SEVEN DIALS TRUST REPOSE TO CAMDEN STREET PROPOSALS

Wp ref: 7D/LBC/2022 12 16 Camden proposals

Camden's Introduction to the current proposals refers to '... a set of conceptual principles to aid in the delivery of a new public realm'. Seven Dials does not need **a new public realm**. The Introduction refers to '*exciting opportunities...*' and '*... the temporary schemes have also served as a good test to longer term opportunities.*' These temporary schemes were intended to support hospitality during the pandemic and now that the West End and Covent Garden are swiftly becoming as they were pre pandemic this rationale no longer applies.

Earlam Street West footway parking.

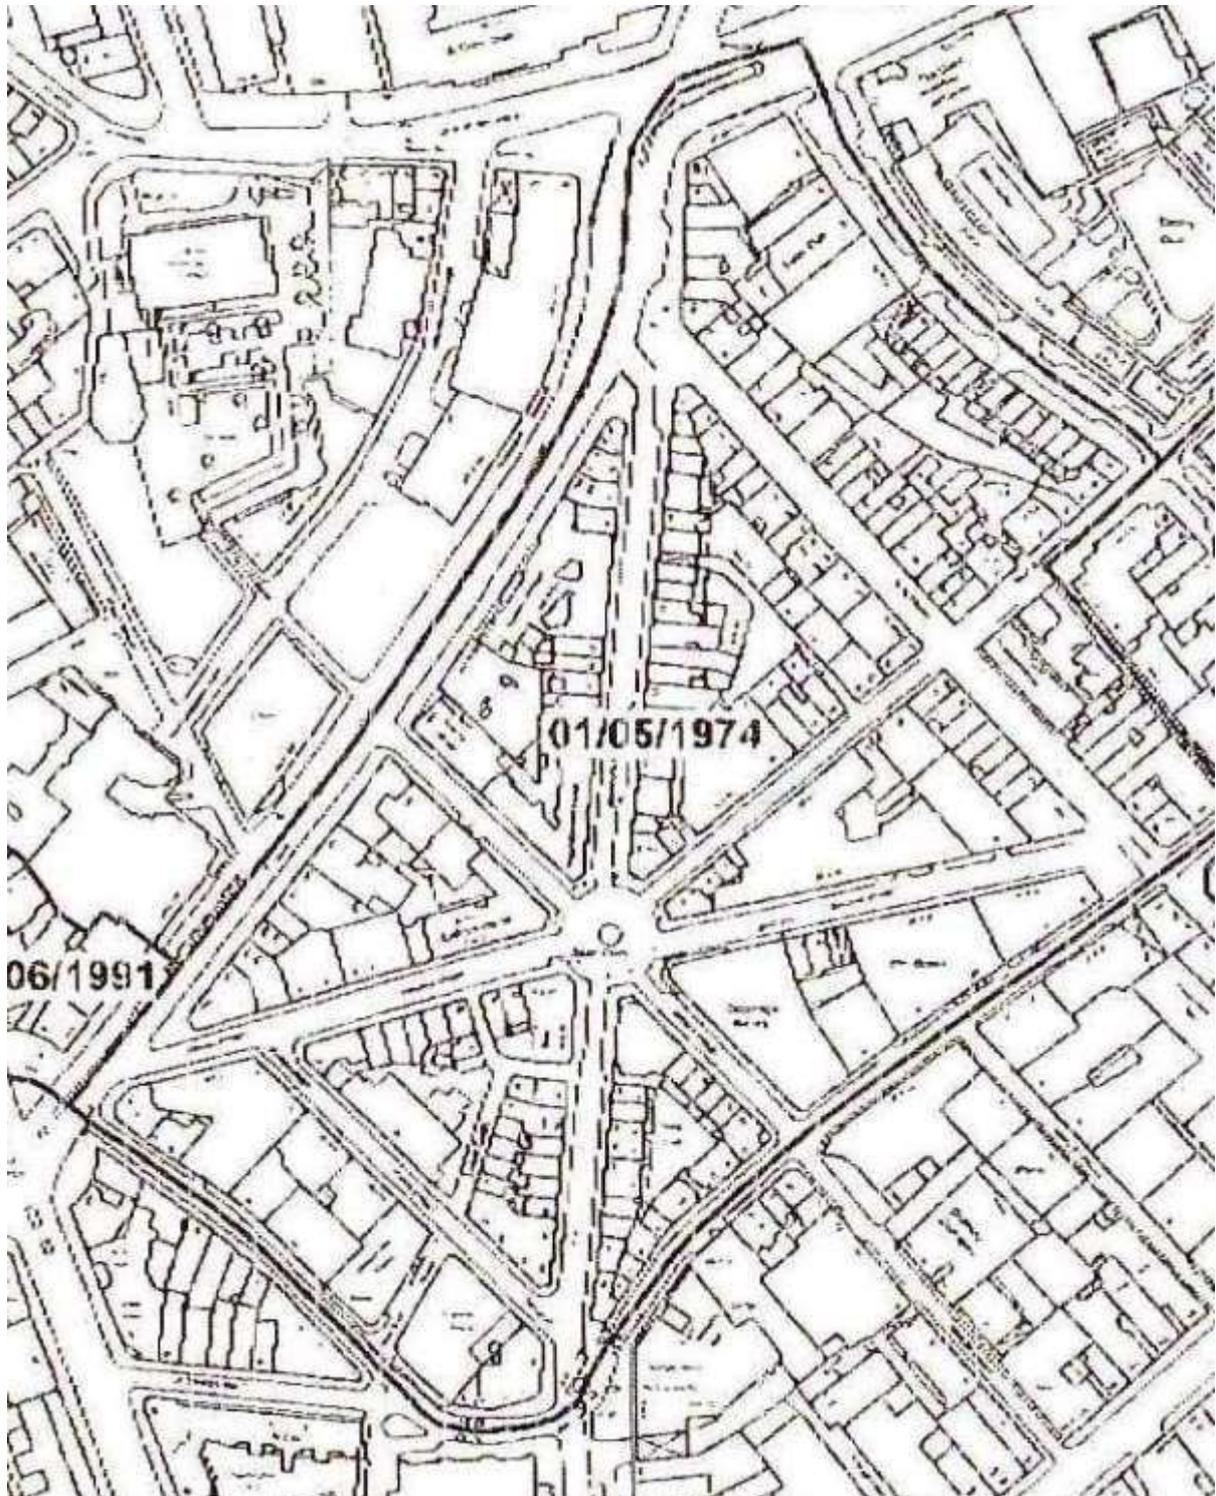
There is little point in relying on non-existent enforcement and facts need to be confronted. The Trust proposes that the narrow Seven Dials bollard be installed on NAL sockets, at the minimum distance to prevent the above from occurring. They also serve the purpose of denoting 'Seven Dials' and as with street furniture in the past, are decorative. Given the increased pedestrian flows from the Elisabeth Line it is essential that footway widening serves to accommodate pedestrians and not parking, planters and al fresco dining.

APPENDIX 3 EATING & SEATING

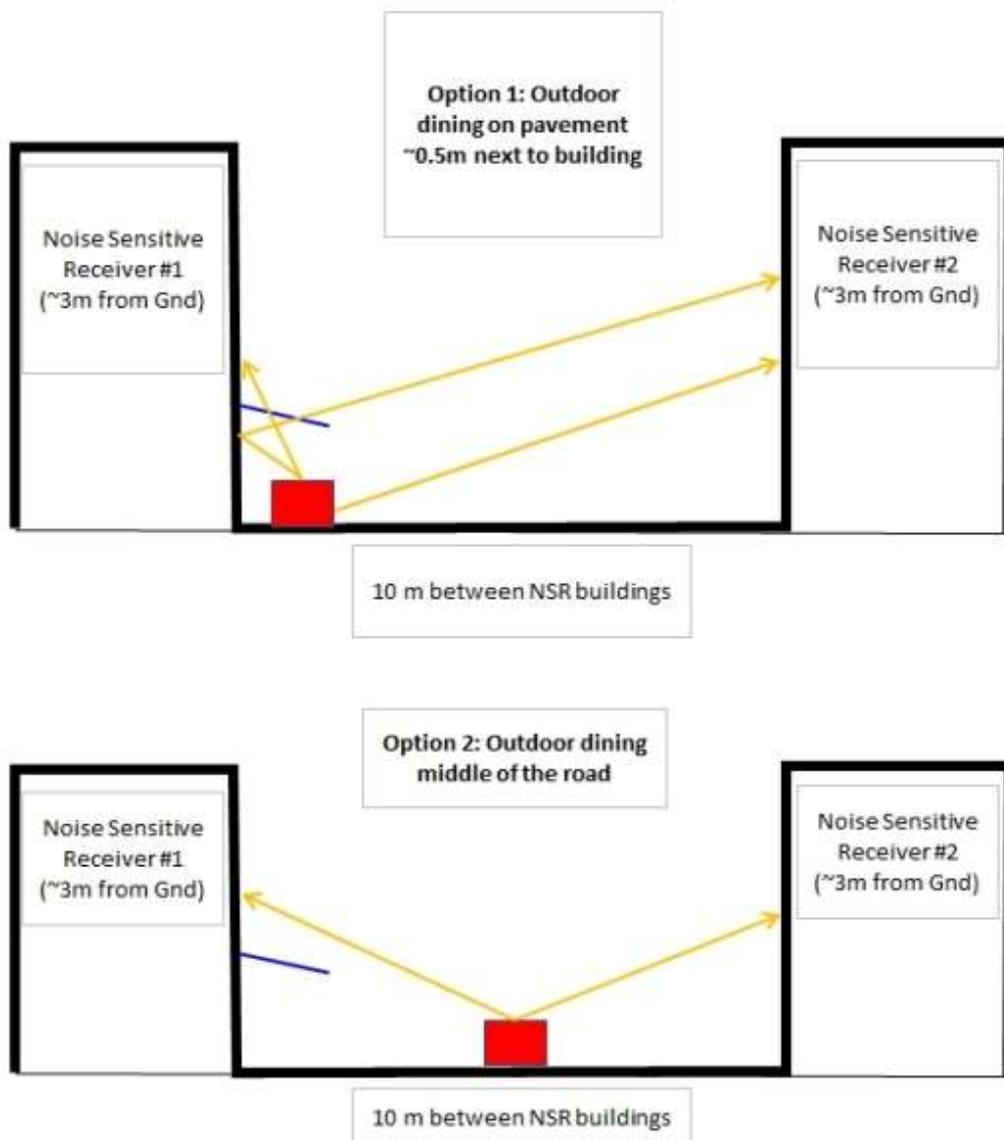
As can be seen from below, bistro strips with awnings above minimise noise to upper floor users, whilst seating further out maximises noise in high density mixed use streets. It is the Trust's view that in such high density mixed use streets bistro strips assist hospitality venues and minimise nuisance to upper floor users and that noise calculations should be made in advance of any new al fresco to ensure that WHO and other noise standards are adhered to.
